**AGENDA**  
**Hailey Planning and Zoning Commission**  
**Monday, July 15, 2024**  
**5:30 p.m.**

**STAFF REPORT**  
**Hailey Planning and Zoning Commission**  
**Regular Meeting of July 15, 2024**

**Overview:** Continuation of a Design Review Application by Eric Cueva, represented by Youdall Architecture, for a mixed-use development project which includes an 880 square foot retail trade commercial space, an 877 square foot detached garage addition, as well as a new 579 square foot Accessory Dwelling Unit (ADU) located above the addition. This project is located at 504 S. Main Street (Lots S20' of 12 All of 13 & 14, Block 9, Hailey Townsite) Business (B), Downtown Residential Overlay (DRO) and Townsite Overlay (TO) Zoning Districts.

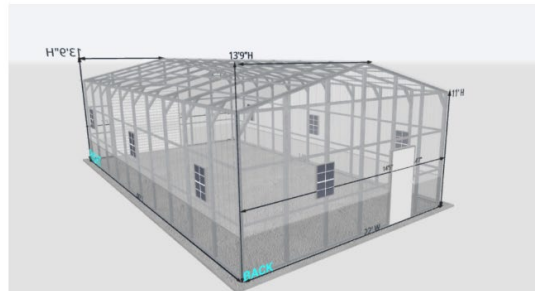
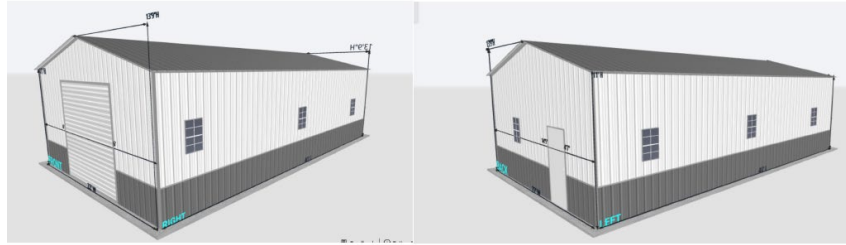
However, the building elevations and floor plans for the proposed commercial structure were significantly lacking in design considerations and details that are Design Review requirements for non-residential and/or mixed-use buildings within the City of Hailey. The initial building elevations submitted for the commercial building were as follows:

In regard to the commercial structure, specific Standards that were found to be inadequately met during previous Design Review submittals and Public Hearings included:

- *17.06.080(A)2c: At ground level, building design shall emphasize human scale, be pedestrian oriented and encourage human activity and interaction.*
- *17.06.080(A)2d: The front façade of buildings shall face the street and may include design features such as windows, pedestrian entrances, building off-sets, projections, architectural detailing, courtyards and change in materials or similar features to create human scale and break up large building surfaces and volumes.*
- *17.06.080(A)2j Gabled coverings, appropriate roof pitch, or snow clips and/or gutters and downspouts shall be provided over all walkways and entries to prevent snow from falling directly onto adjacent sidewalks.*
- *17.06.080(A)3a Accessory structures shall be designed to be compatible with the principal building(s).*

The Applicant revised their building elevations and resubmitted plans for an additional Design Review continuation by the Commission, to be heard on July 15, 2024. The revised building elevation is as follows:

Additionally, the Applicant submitted building elevations at record grade, as well as a floor plan, per Design Review submittal requirements. Staff believe that in terms of the commercial building design, the Applicant has submitted plans that are complete and consistent with Hailey Municipal Code requirements. The Commission may wish to focus on these outstanding commercial building design requirements in this iteration of the Applicant’s Design Review Public Hearing.
